U.S. Department of Energy
Attention: Comments--EA
1000 Independence Avenue, SW
Washington, DC 20585

SEARCH technical services
(509) 725-6666
STAR ROUTE BOX 17, DAVENPORT WA 99122

REFERENCE: Technical Review Comment on To: Justus
DRAFT EA: REFERENCE REPOSITORY LOCATION,
HANFORD SITE, WASHINGTON, December 1984.
SEARCH : 5545

FIGURE 1.

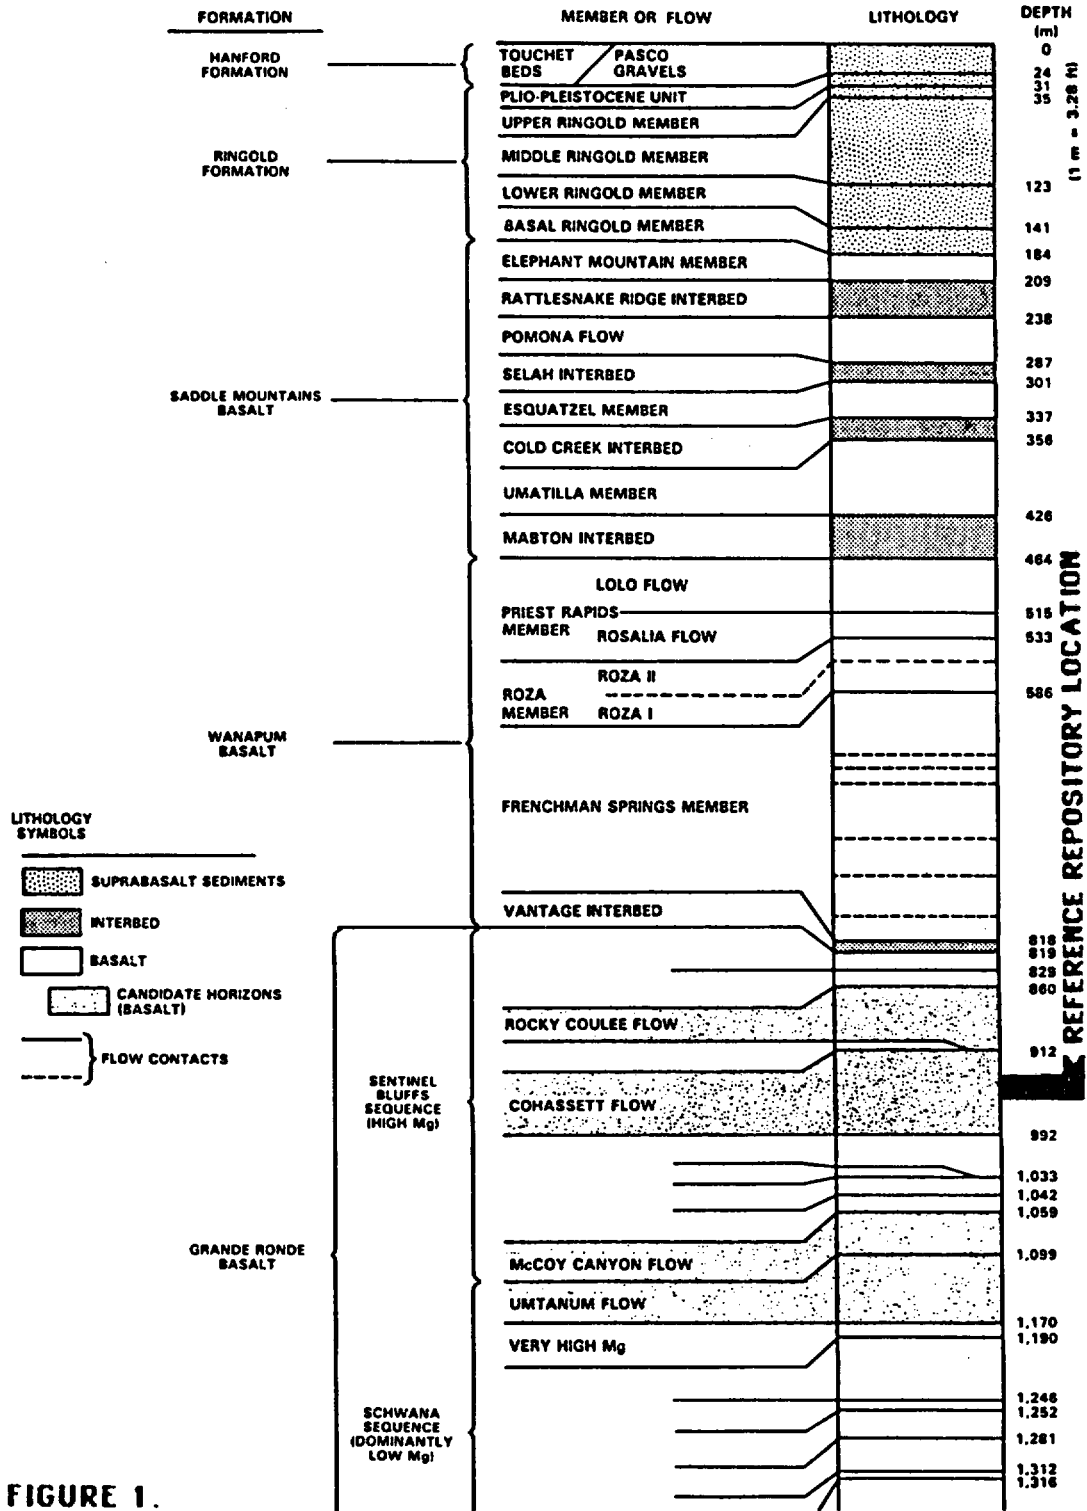
This review assumes that the repository is emplaced within the Cohasset Flow of basalt at a depth of about 3,000 feet, Fig. 1 [2]. This review further represents that accessible environment to be the Columbia River which is about 60,000 feet to the east of the reference repository location, Fig. 2 [3]. Corresponding to these vertical and horizontal scales, any significant pathway

FIGURE 3. TRITIUM HISTORY OF WELL 699-2-3

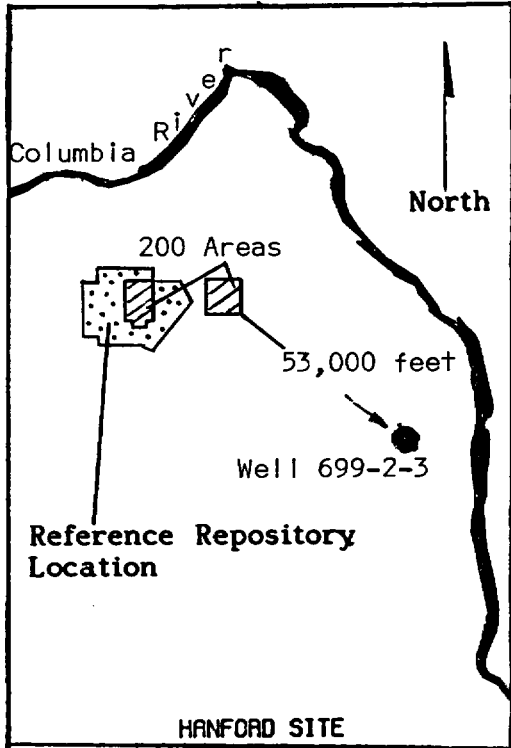
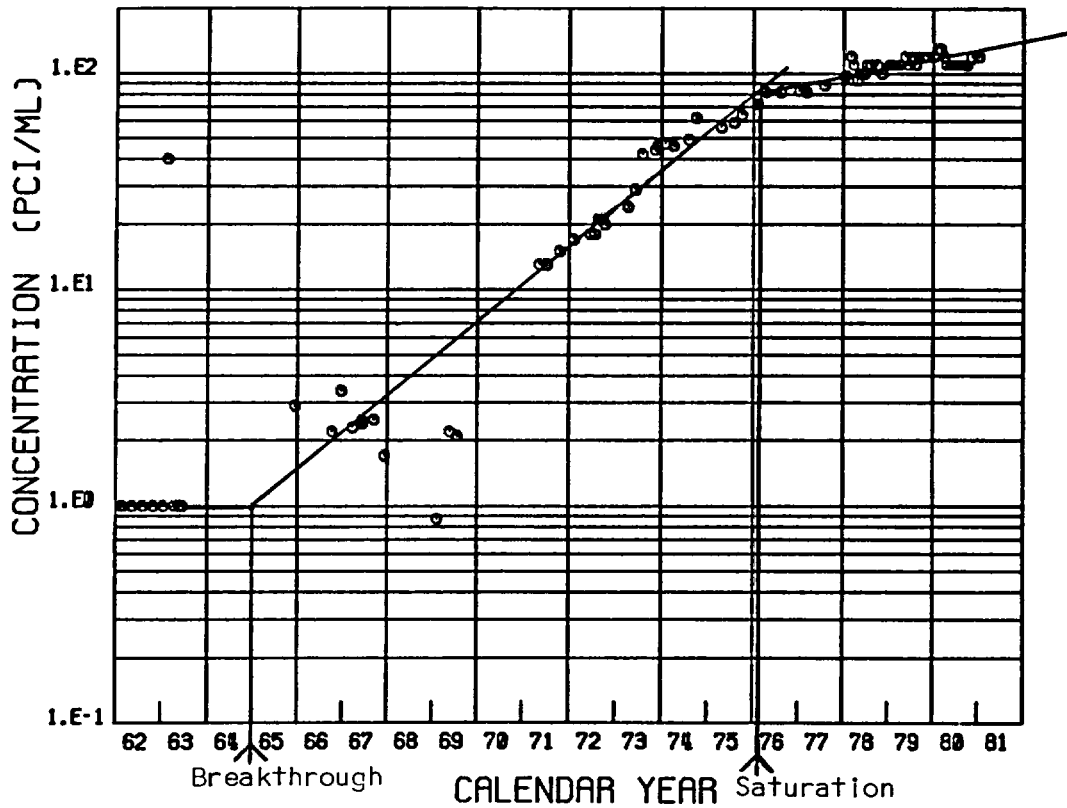
Fig. 3 [4]. The site map in Fig. 3 shows that Well 699-2-3 is about as far east of the 200 East Area as the Columbia River is east of the reference repository location. That is, this 21-year period is a crude estimate of the travel time which might be expected for the horizontal leg of a sedimentary pathway connecting the repository to the Columbia River.

Well 699-2-3 was selected for this travel time estimate because its tritium record is particularly simple: There is an abrupt breakthrough of tritium-bearing water in 1965, followed by an exponential increase in concentration, followed by near attainment of saturation concentration in 1976.

Breakthrough, however, does not imply a significant release of radionuclides to the Columbia River. As Fig. 3 shows, the breakthrough concentration of radionuclides is negligible: The maximum concentration of radionuclides released to the Columbia River requires about 50% more time. That is, the expected travel time for significant radionuclide travel to the Columbia River is

FIGURE 4.

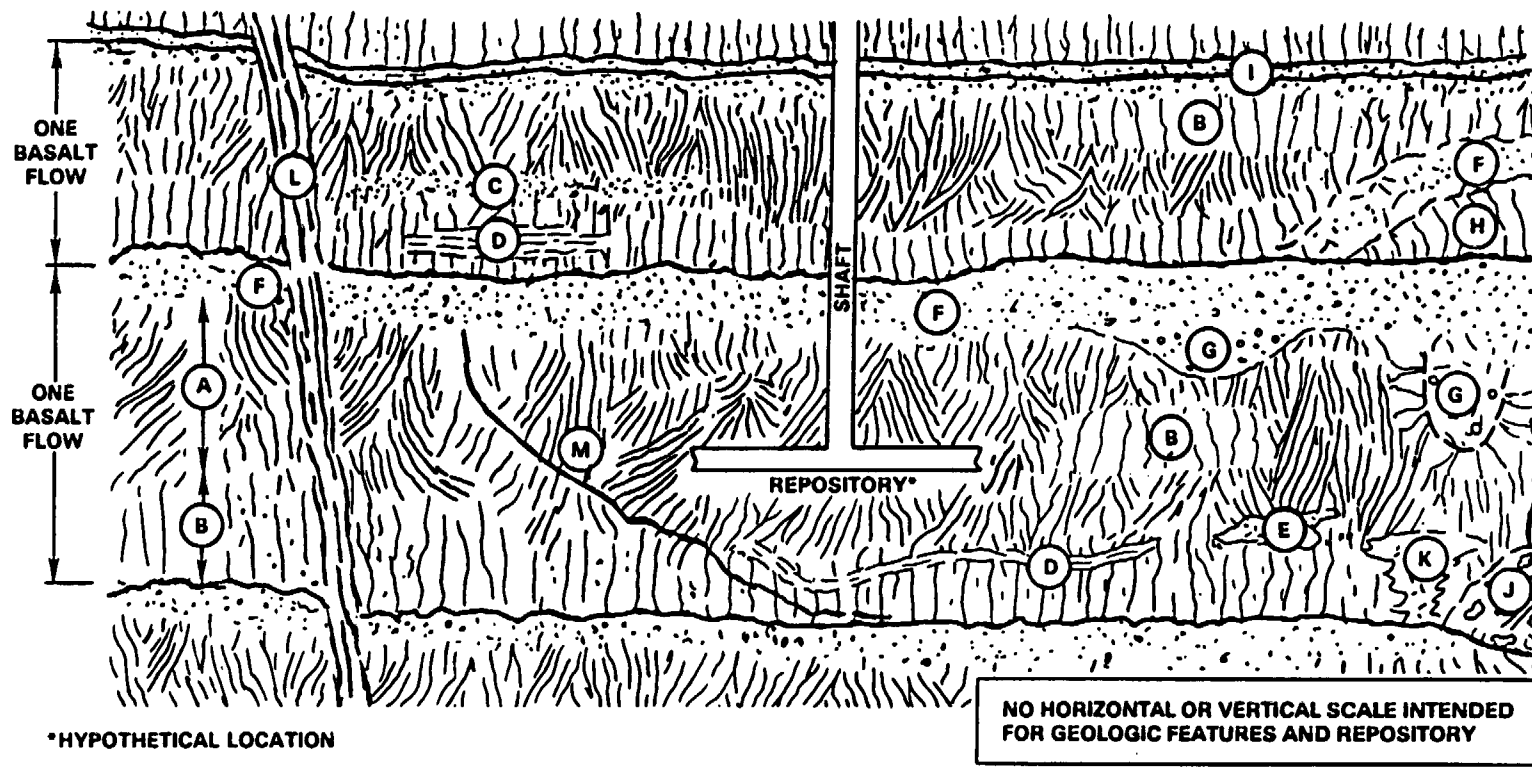
Figure 4, taken from the DEA, provides a hypothetical, composite cross section of possible geologic features in a layered basalt sequence with the repository sketched [4]. This figure shows an interbed situated one basalt flow above the basalt flow in which the repository is located. Furthermore, Fig. 4 shows a major fault or fracture which connects the level of the repository with the level of the interbed. That is, Fig. 4 presents hypothetical vertical and horizontal legs of a pathway which might connect the repository to the Columbia River.

FIGURE 5.

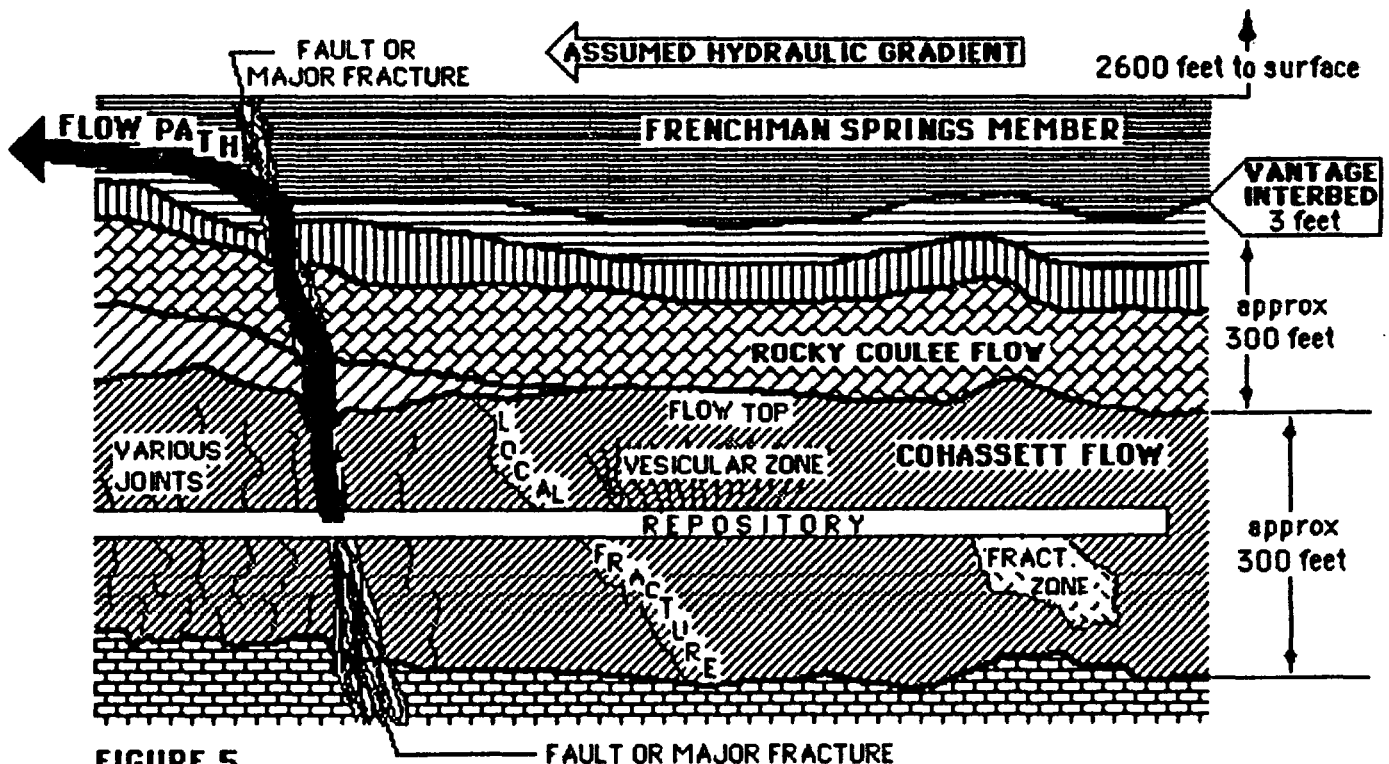
stratigraphy (Fig. 1) may be combined with the hypothetical geologic features of Fig. 4 to allow some appreciation of possible spatial relationships. Figure 5 is the diagrammatic result, with the repository shown in the Cohasset Flow which the DEA finds to be most geologically promising [6].

The striking feature of this scaling of the actual structures is the great horizontal extent—about 11,000 feet [7]—of the repository.

Figure 5 shows this scaled repository to cross several vertical discontinuities in the Cohasset Flow. The most severe of these discontinuities, a fault or major fracture, is shown as connecting the repository to the Vantage Interbed, some 400 feet above it.

The next step is to estimate how likely it is that the 120,000,000 square-foot repository will actually intersect such a fault or major fracture. Three lines of inquiry suggest that such intersection is very likely: (1) One major discontinuity, the "Cold Creek Barrier," is already identified next to the reference repository location, in DEA Fig. 3-1. (2) General descriptions of Central Basin basalt outcropping [8] and easily made observations from roadways reveal major vertical discontinuities with horizontal scales much less than the repository scale. (3) General consideration of quasi-static plate failures suggests fracture spacing on the order of plate thickness, in this case less than 1,000 feet. On this basis, an arrow is drawn into Fig. 5 to depict the probable, significant flow pathway for the reference repository location in the Cohasset Flow.

FIGURE 7.

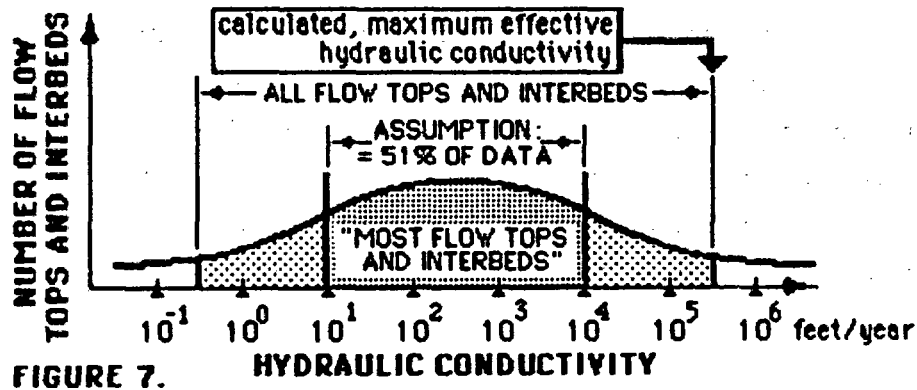
In the absence of a published value of this critical datum, a representatively large conductivity for an interbed may be estimated from the observation that hydraulic transmissivity data for the basalt-flow tops in the Grande Ronde Basalt are log-normally distributed. Then if one also applies this probability distribution to hydraulic conductivities for the 12 major stratigraphic features within 1,000 feet over the Cohasset Flow reference repository location (Fig. 1), the maximum feature conductivity--presumably of the Vantage Interbed--may be estimated. For this estimation, the meaning of "most" individual flow tops and interbeds is equated to 51% of those flow tops and interbeds. For the log-normal distribution, this 51% range corresponds to 0.69 standard deviations from the log-mean. Also for the log-normal distribution of hydraulic conductivities, the conductivity of the most conductive stratum of 12 strata is expected to occur at 1.39 standard deviations about the log-mean. Figure 7 diagrams the analysis. According to this calculation, the most conductive stratum of the 12 strata above the repository would have an expected hydraulic conductivity of 3×10^5 feet/year. (If this extrapolation is incorrect, DOE will presumably publish data demonstrating that no interbed hydraulic conductivity measurements have values this large.)
